LICENSING REPORT
DRESDEN NUCLEAR POWER PLANT
UNITS 2 AND 3
SPENT FUEL RACK MODIFICATION

DOCUMENT #: QUAD-1-79-234

REVISION NO. 4

REVISION SHEET

FIGURE 3.1-1. DRESDEN UNITS 2 AND 3 - SPENT FUEL POOL ARRANGEMENT WITH EXISTING SPENT FUEL RACKS - 2840 TOTAL SPACES

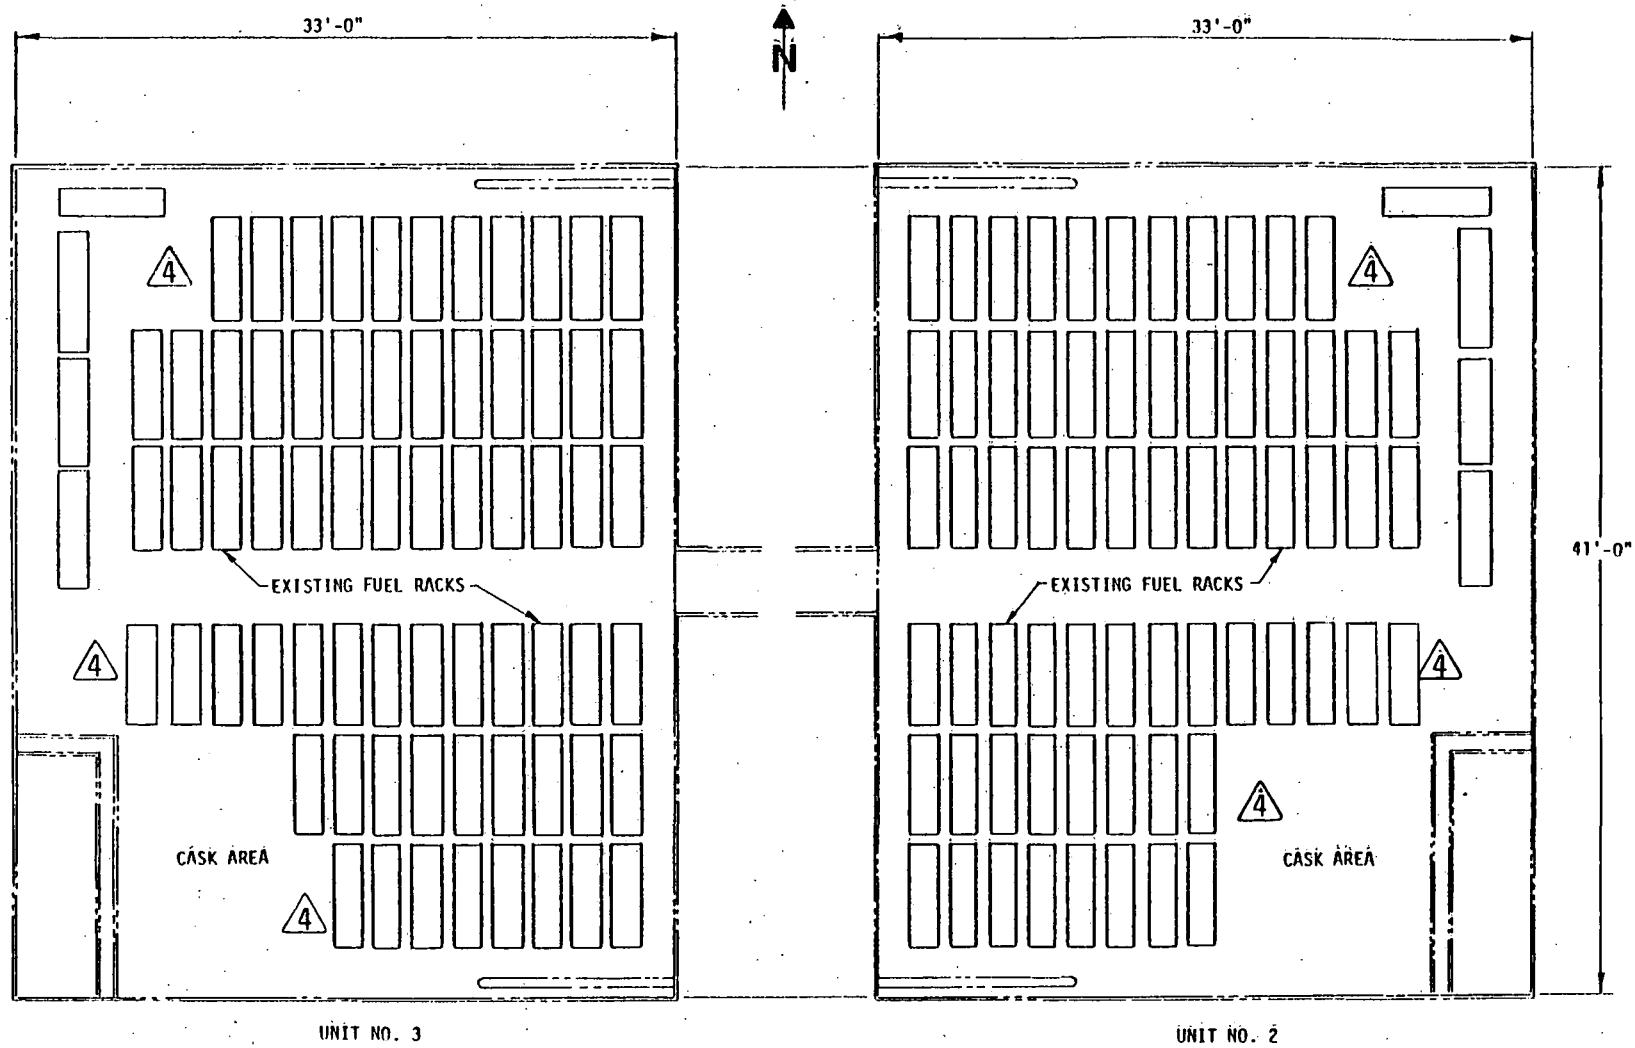
ITEM	DESCRIPTION	PAGE NO.
1.	Figure 3.1-1 - Corrected fuel storage rack arrangement to show present layout.	3-4
2.	Figure 3.2-1 - Revised length of Boral from 144" minimum to show correct length of 156". - Deleted reference to aluminum filler.	3-7
